Memo

Date: May 29, 2020

Re: Dewey Development – Detailed Site Plan (DSP-19050-01)

Exhibit 7. First Floor Entrance, Multifamily Condominiums

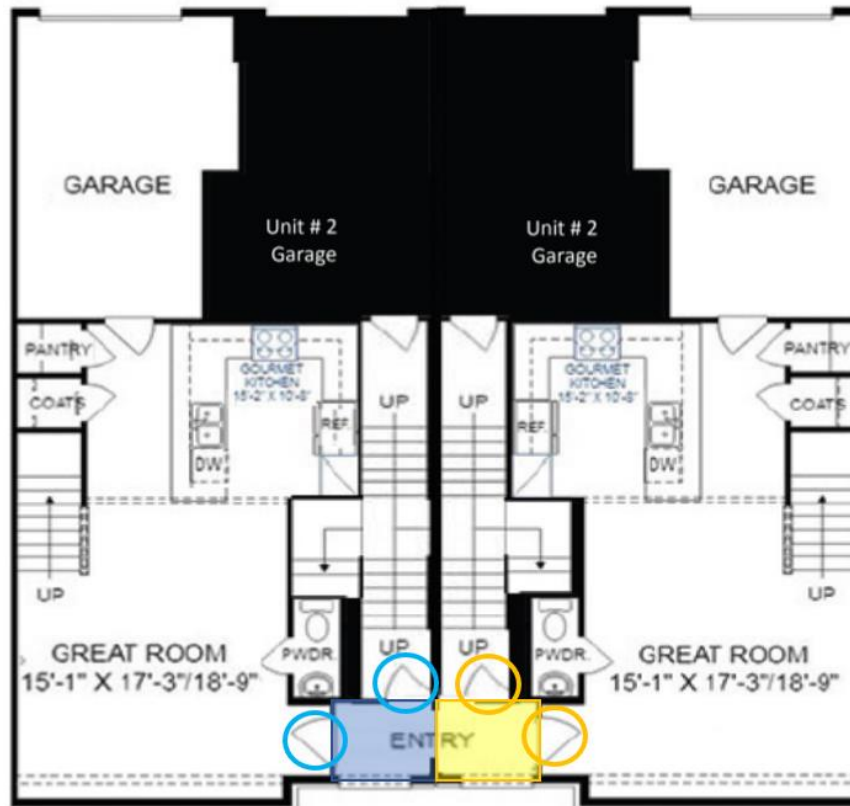
City Staff recommends the following conditions related to the architecture of products on Parcels 2 & 3:

1. **All front entrances be outfitted with overhead canopies to shield residents from the elements and provide visual interest.**
2. **Rear façades and side units, especially those that are visible from public roadways, include additional colors or materials to break up the repetitiveness of the current design.**

2. The applicant shall ensure all units on Parcels 2 and 3 have adequate access for fire and other emergency vehicles.
3. All front entrances of the proposed multifamily condominiums shall be outfitted with overhead canopies.

Exhibit 9. Trail through Stormwater Management Facility, Parcel 4

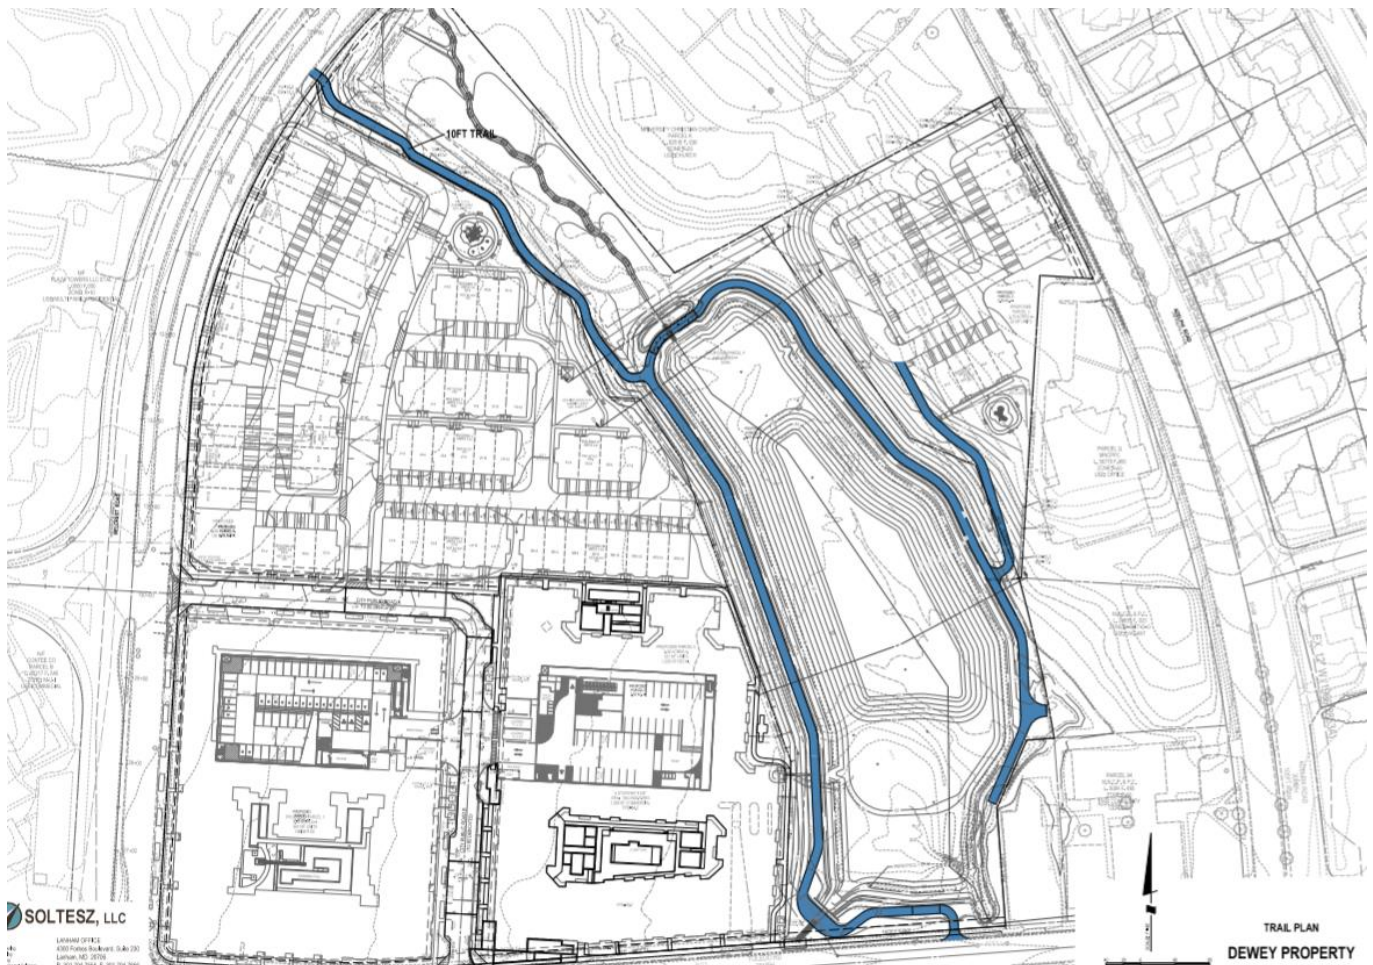
City Staff recommends, if deemed feasible by M-NCPPC and County DPW&T, the trail make a full loop, connecting the ends of the trail on the southeast corner of Parcel 4. In addition, City Staff recommends way-finding signage and vinyl treatment fencing be integrated into the design and construction of the trail to ensure pedestrian safety if required by Prince George’s County Department of Environment guidelines.

5. If deemed feasible by M-NCPPC and County DPW&T, the pedestrian trail on Parcel 4 shall form a connected loop around the stormwater pond. The trail shall integrate appropriate wayfinding signage and vinyl treatment fencing to ensure pedestrian safety if required by Prince George’s County Department of Environment (DER) guidelines.

Exhibit 15. Deviation from Build-to Line for Parcels 1 & 2 (Modifications 4, 5, 6, & 7)

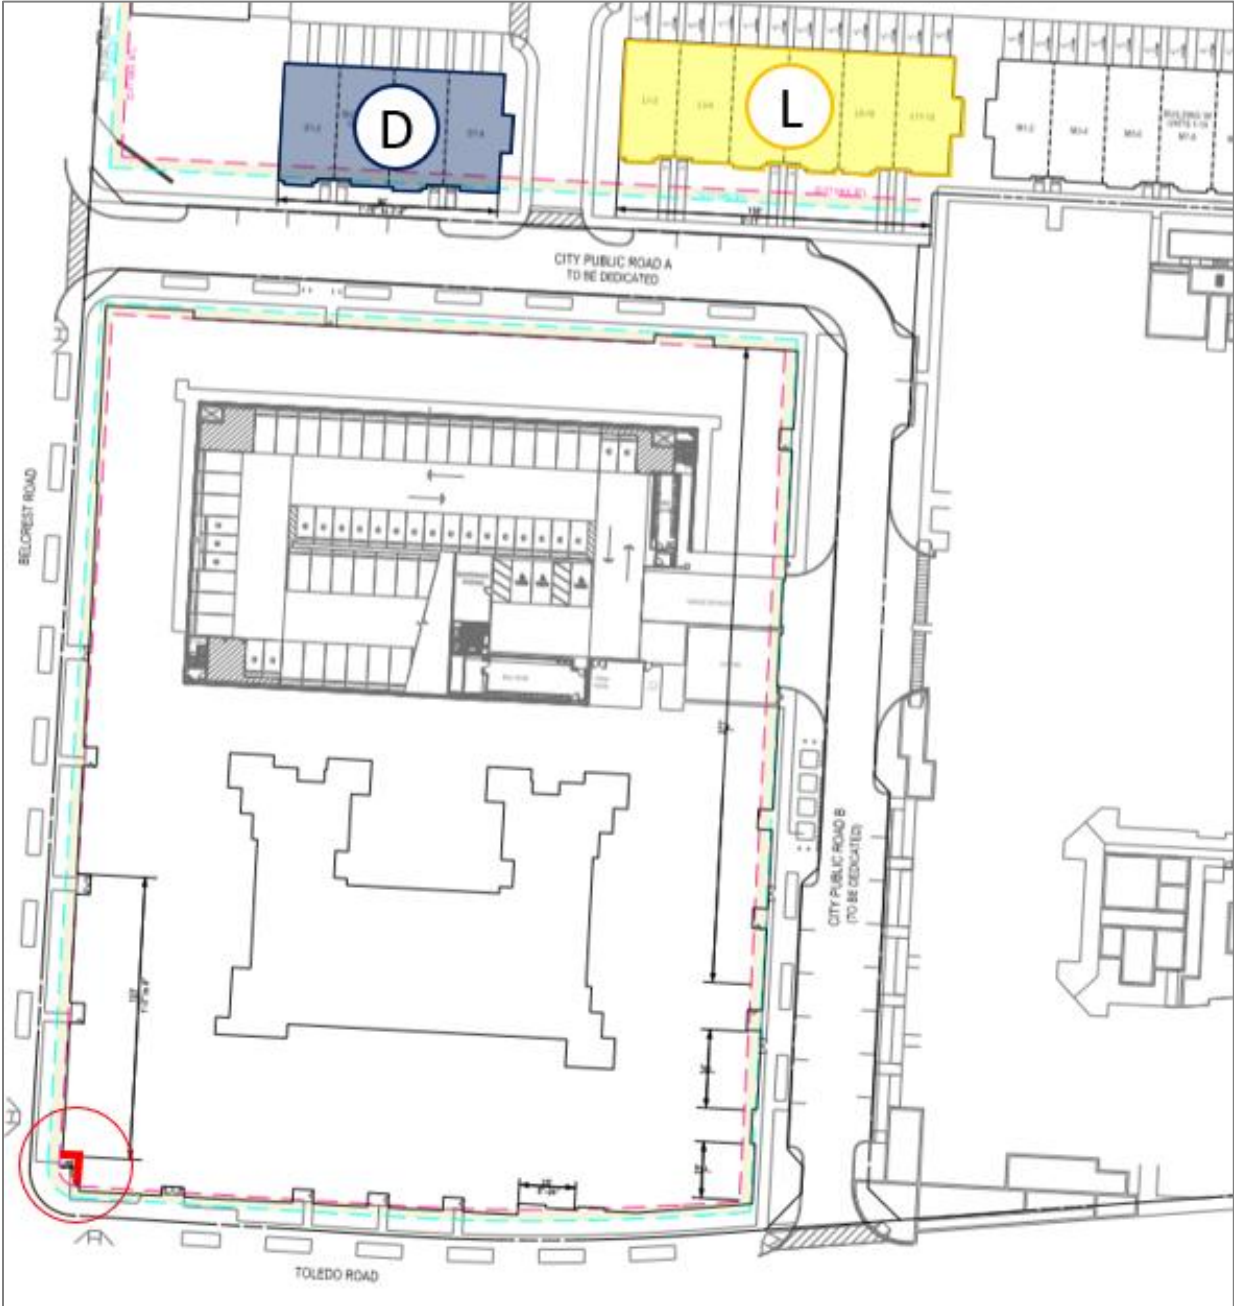
The applicant’s requested modifications, associated standard, and Staff’s comments are outlined in the table attached.
